ABBOTT ADD	INDEX TECHNICAL SERVICE BULLETIN
---	---

PRODUCT: TDx® (09)	DATE: 22-APR-98
-------------------------------------	----------------------------------

ABBOTT ADD	<h1>TECHNICAL SERVICE BULLETIN</h1>
--	-------------------------------------

SUBJECT:
TDx® Analyzer Revision 16.0 Software Upgrade

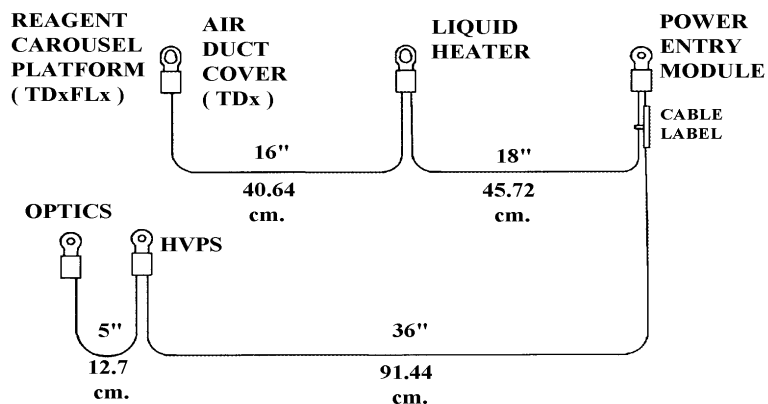
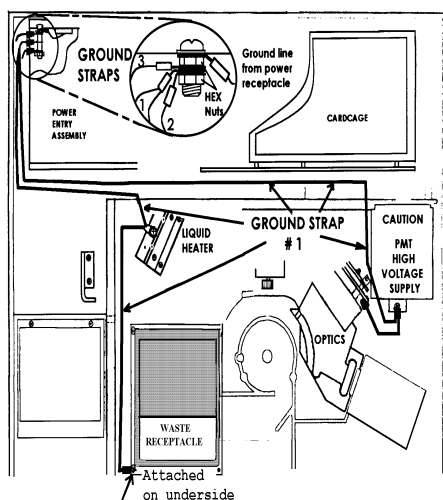
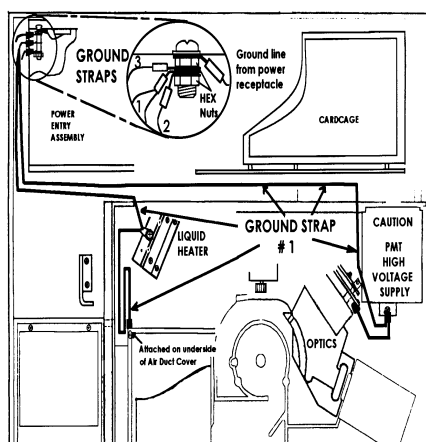
STEP 8. On the Power Entry Assembly, locate and remove the screw and nut that attaches the ground wire from the receptacle ground lug to the Power Entry Assembly. Install the screw from BAG A, attach the ground wire from the receptacle ground lug over the screw, and secure the ground wire using one of the nuts from BAG A.

Tightly attach the three (3) ground harnesses, in order, to this grounding screw with the second nut from BAG A.

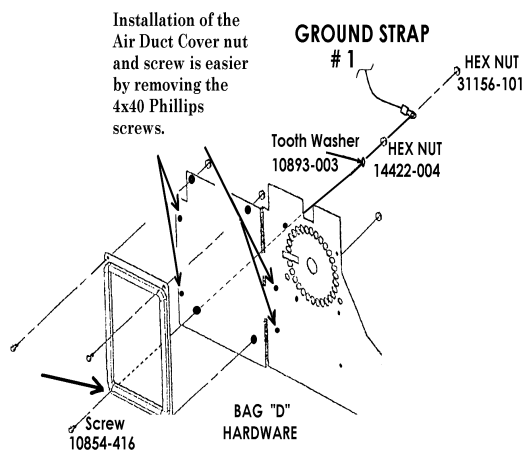
With the Air Duct Cover still installed in the instrument, remove the left front screw and nut that holds the Waste Receptacle to the Air Duct Cover. Install the screw from BAG D through the Air Duct Cover and attach the washer and the 14422-004 standard nut from BAG D on the underside of the Air Duct Cover. Tighten the nut so the washer "cuts" into the Air Duct Cover.

Attach the ground strap to the Air Duct Cover, as illustrated below, using the 31156-101 KEP Hex Nut from BAG D.

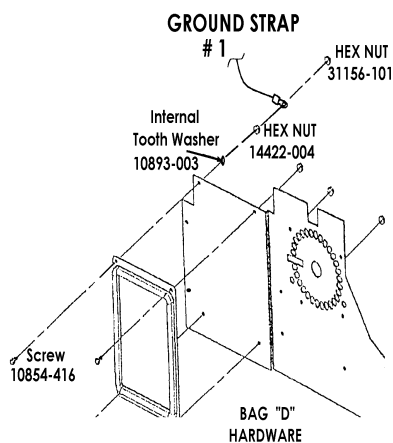
STEP 10 On the Air Duct Cover, remove the screw and nut located at the top left corner. This screw and nut are one of four that hold the Waste Tray Receptacle onto the Air Duct Cover. Install the screw from BAG D through the Air Duct Cover and attach the washer and the 14422-004 standard nut from BAG D on the underside of the Air Duct Cover. Tighten the nut so the washer "cuts" into the Air Duct Cover.

Attach the ground strap to the Air Duct Cover, as illustrated below, using the 31156-101 KEP Hex Nut from BAG D. Install the Air Duct Cover into the instrument.

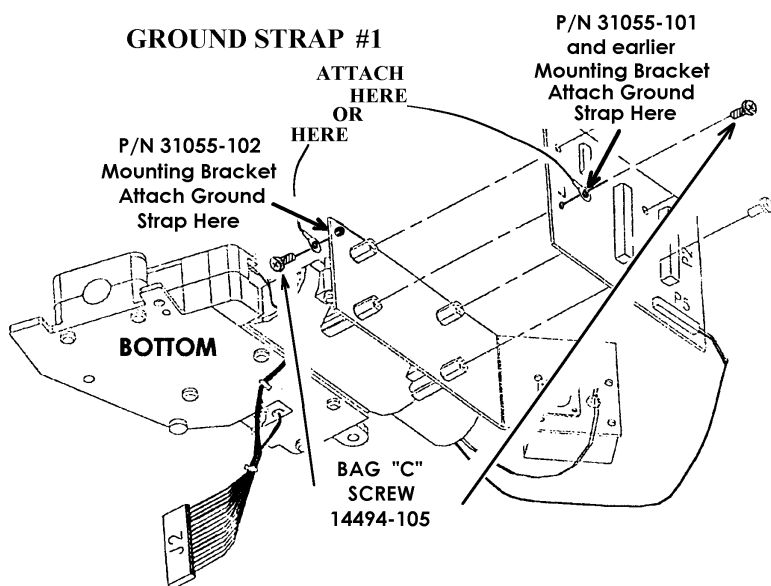
STEP 11 Referring to the illustration below, attach the ground strap, to the one (1) appropriate location on the Optics Assembly.

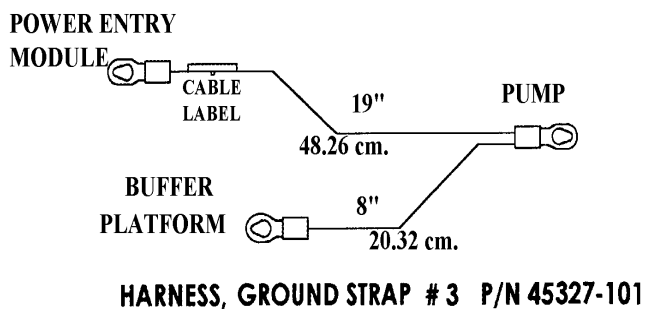
STEP 11 Referring to the illustration below, attach the ground strap, to the one (1) appropriate location on the Optics Assembly. Install the Optics Assembly and the Boom Assembly into the instrument.

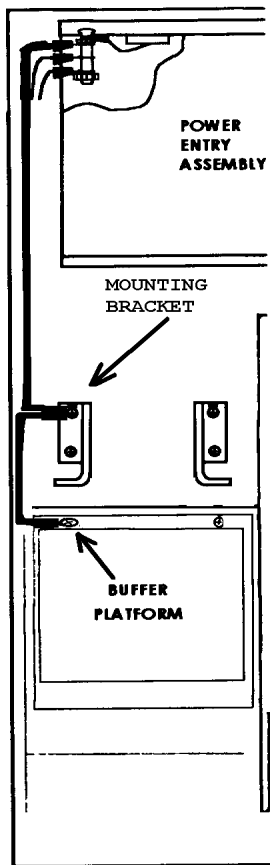
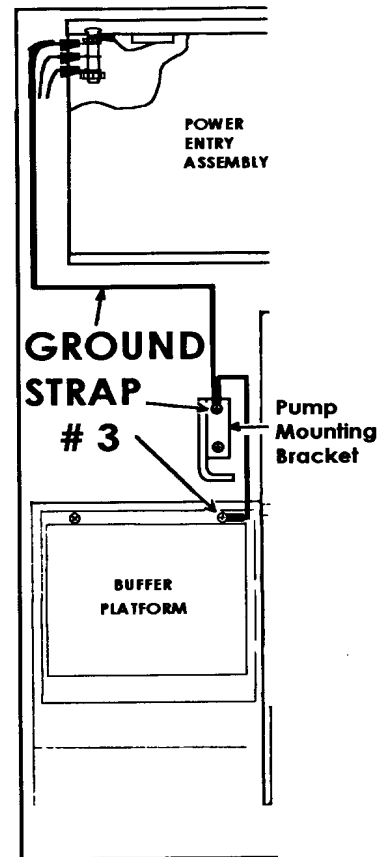
STEP 12 HARNESS GROUND STRAP #3. Attach ground strap #3 to the back screw that secures the pump mounting bracket to the instrument base. Then route the ground strap under the Pump Assembly front cover and attach to the Buffer Platform.

HARNESS, GROUND STRAP #2 P/N 45206-102

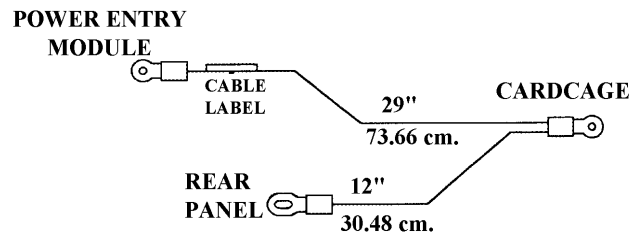
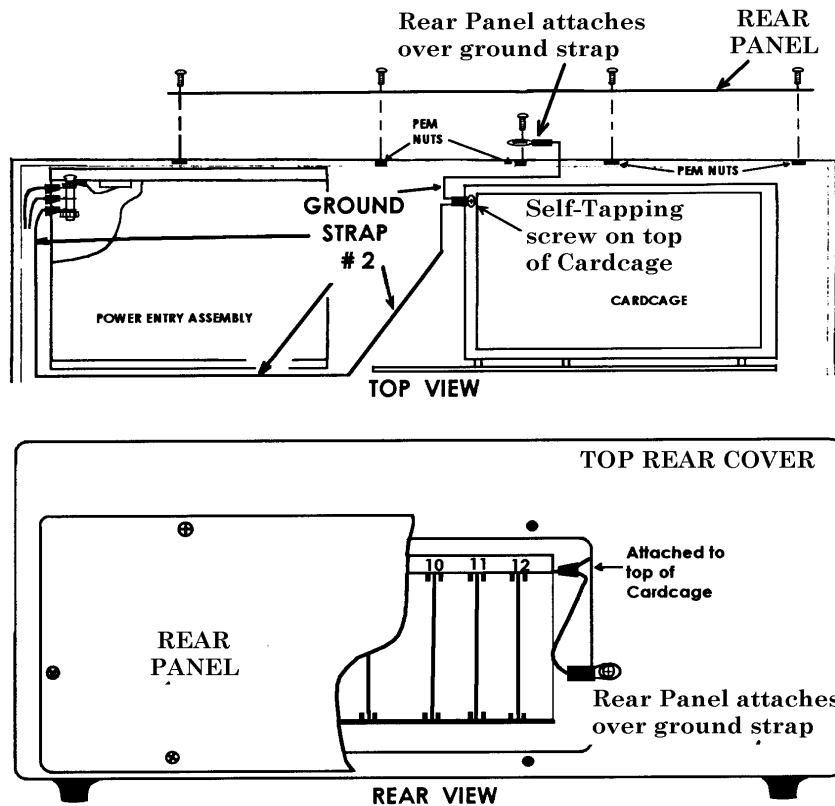
STEP 13 HARNESS GROUND STRAP #2. Remove the self-tapping screw from the top of the cardcage. Attach the ground strap #2 to the top of the cardcage using the self-tapping screw.

- STEP 14** Install the Left Side Panel and the Top Rear Cover. Plug P9 and P10 for the printer into their respective connectors on the Motherboard PCB.
Using the 14494-206 screw from BAG B attach Ground Strap #2 to the outside of the Top Rear Cover as shown.

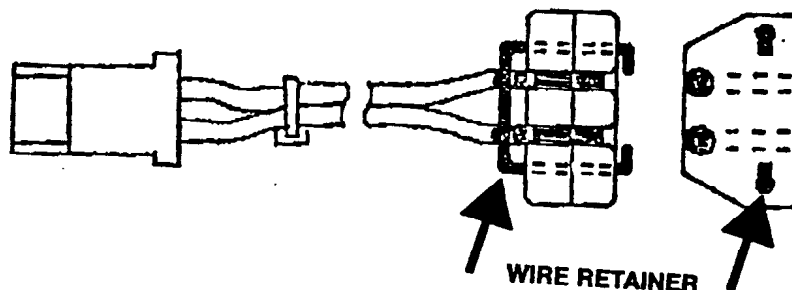
A wire retainer was added to the Lamp Socket to relieve stress on the wires during lamp replacement. This improvement is made to reduce LAMP OUT errors.
